December 5, 2001
NOC-AE-01001222

South Texas Project
Unit 2
Docket No. STN 50-499
Response to Request for Additional Information Regarding the
2RE08 Steam Generator Tube Voltage-Based Repair Criteria 90-Day Report

RESPONSE TO NRC REQUEST FOR ADDITIONAL INFORMATION

Figure 2-1: Comparison of POL Curves Using ODSCC Data

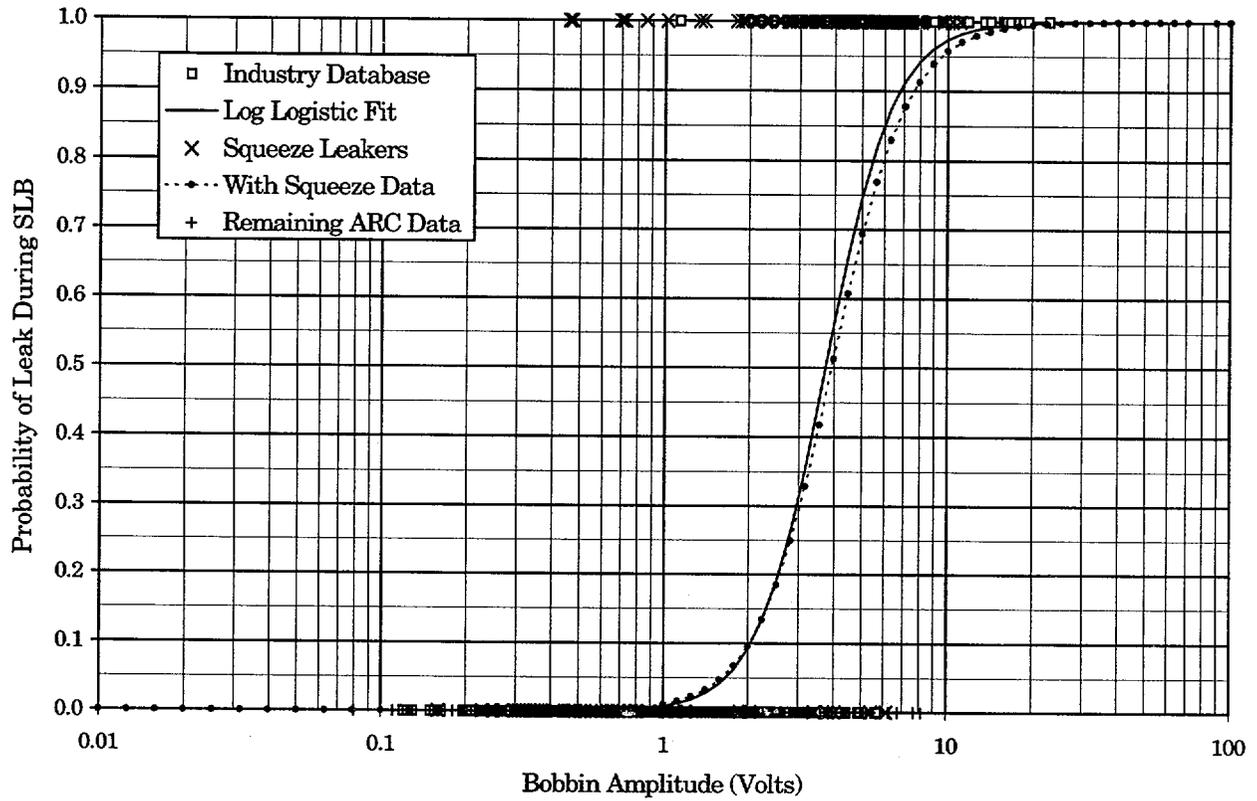
As discussed in Reference 3, operational primary-to-secondary leakage was identified during Cycle 8, and a 600 psi secondary side pressure test was conducted during the subsequent refueling outage to identify possible leaking tubes. The leakage rate under the test conditions was no greater than 1 drop per minute and many tubes did not drip at all rather they were just wet. In Reference 2, 54 tubes with indications above 4 volts were identified as leakers during this pressure test. In addition, in Reference 4, it was indicated that approximately 40 tubes were preventively plugged due to being suspected leaking tubes (presumably these were below the repair limits). During the April 19 meeting, a table listing all of the tubes identified as leakers during the secondary side pressure test was provided along with the voltages for tube support plate indications. Several of these tubes leaked even though the indications in the tube were of relatively small voltages (and the differential pressure during the pressure test was less than would be experienced during a steam line break). Are the results of the secondary side pressure test consistent with the generic probability of leakage model? For the tubes that leaked during the pressure test, please provide a list of any other eddy current indications detected in these tubes (e.g., wear, free span indication, etc.) and address the possibility that these indications were contributing to the leakage.

A very conservative POL evaluation was performed assuming that all tubes implied to be leaking were indeed tubes that would leak during operation, i.e., "squeeze leakers". The remaining indications found during the inspection are considered to be non-leakers. A POL regression analysis was performed using this database and the analysis results were compared to the result using the EPRI generic database of test results. Figure 2-1 illustrates the data and the results of the analysis. The specified squeeze leakers are shown with a POL of 1. The remaining indications used in the ARC analysis are shown as "+" symbols with a POL of 0. The solid line on the figure illustrates the EPRI database solution and the solution using the STP ODSCC data is shown using a dashed line. The results from this analysis support the use of the POL curve

obtained from the generic database. The two curves are in quite good agreement up to bobbin amplitudes of 2 volts. The ARC data beyond that indicate that a POL lower than that of the EPRI generic curve might be expected. A second analysis was initially considered that would assume that only the tubes actually observed to drip during the secondary side pressure test were leakers. However, given the result from the first analysis, the need for the second analysis is obviated, i.e., the match to the generic curve would only be expected to improve or confirm that the generic curve is conservative.
